# UNITED STATES PATENT AND TRADEMARK OFFICE

APPLICATION NO.	FILING DATE	FIRST NAMED INVENTOR	ATTORNEY DOCKET NO.	CONFIRMATION NO.
10/716,260	11/18/2003	Vitaliano Russo	7202-48	6498
30448	7590	02/08/2006	EXAMINER	
AKERMAN SENTERFITT P.O. BOX 3188 WEST PALM BEACH, FL 33402-3188			FERGUSON, MICHAEL P	
			ART UNIT	PAPER NUMBER
			3679

<b>Office Action Summary</b>	<b>Application No.</b> 10/716,260	<b>Applicant(s)</b> RUSSO, VITALIANO	
	<b>Examiner</b> Michael P. Ferguson	<b>Art Unit</b> 3679

## **DETAILED ACTION**

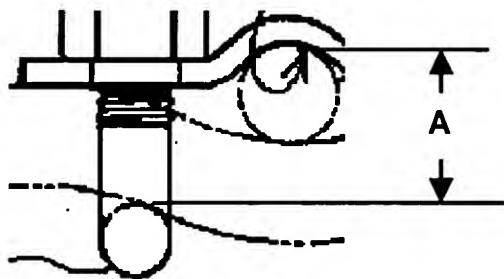
wherein, during the clamping step, the ropes press each other at their crossover area, because of the displacement of contacting rope strands, reducing the overall thickness **A** (Figure 10b shown below with annotations) of the first and second ropes pressed together to 1 to  $\frac{4}{3}$  of the rope diameter (thickness **A** is approximately  $\frac{4}{3}$  the diameter of rope **3,4**) in such a way that the ropes are forced to lie substantially in the same plane at each knot of the net (Figures 9-10b).

wherein the unique piece has a given distance **A** measured between a tangent line at an intrados of an arch of the bridge element and the plane defined by tangent lines at the intrados of curved bases of the first U element and the second U element, and

wherein the give distance is between 1 and  $\frac{4}{3}$  of the rope diameter (Figures 9-10b).

wherein the given distance is between 1 and  $\frac{4}{3}$  of the rope diameter (thickness **A** is approximately  $\frac{4}{3}$  the diameter of rope **3,4**; Figures 9-10b).

Examiner disagrees. As to claims 1,2 and 8, Tesac Corp discloses a knot comprising a first U element **16A** and a second U element **16A** positioned side-by-side astride the first rope, with equally oriented wings at a distance from one another approximately equal to the rope diameter so that they lie close to the second rope on opposite sides thereof; wherein the unique piece has a given distance **A** measured between a tangent line at an intrados of an arch of the bridge element and the plane defined by tangent lines at the intrados of curved bases of the first U element and the second U element; and wherein the given distance is 4/3 of the rope diameter (Figure 10b).
